PRODUCT CHANGE NOTIFICATION

Bourns® 1220 Series UL 1449 Surge Protection Device (SPD)

Type Upgrade

SPD2603

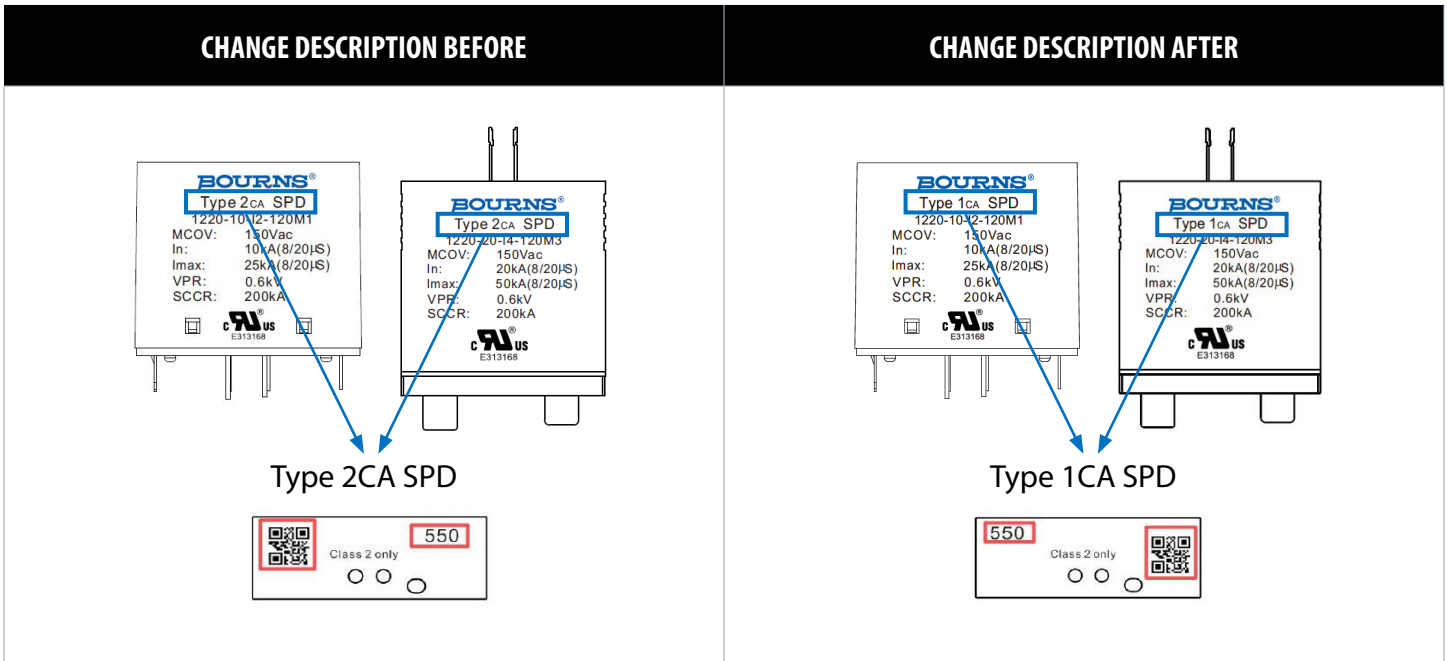
This change to UL 1449 SPD Type will affect the product's form. The printed marking on the module of the affected part numbers will change from "Type 2CA" to "Type 1CA". To improve readability, the position of the markings printed on the top of the casing has been adjusted. The fit, function, quality, and reliability of the affected part numbers will remain unchanged. Traceability will be maintained through lot code and date code.
